CITY OF AUSTIN
RESIDENTIAL PERMIT APPLICATION "A"

BP Number 2007-119518
 Building Permit No. 07-119518
 Plat No. _____ Date 5/7/07
 Reviewer SPB

Service Address 12912 Park Drive Tax Parcel No. _____
 Legal Description _____
 Lot 77 Block A Subdivision Hughes Park Lake Subd. Section 1 Phase _____

Description of Work
 New Residence Finish out
 Duplex _____
 Garage attached detached _____
 Carport attached detached _____
 Pool _____
 Remodel (specify) FINISH OUT - BPO3-8418R
Bldg-Mech, PLUMB
 Other (specify) "Hold" - to comply w/ 2007-118416
 Addition (specify) _____

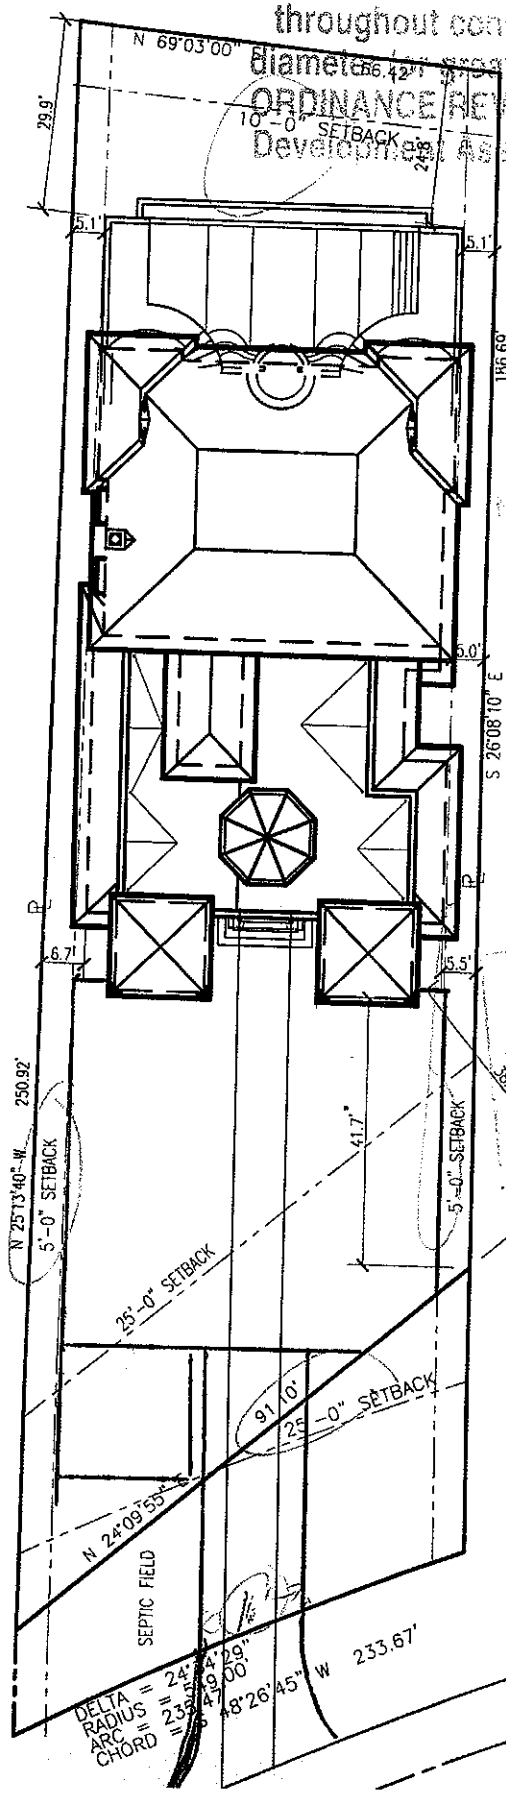
(b) need to know location of driveway & where accessing lot
(d) need to know parking space location
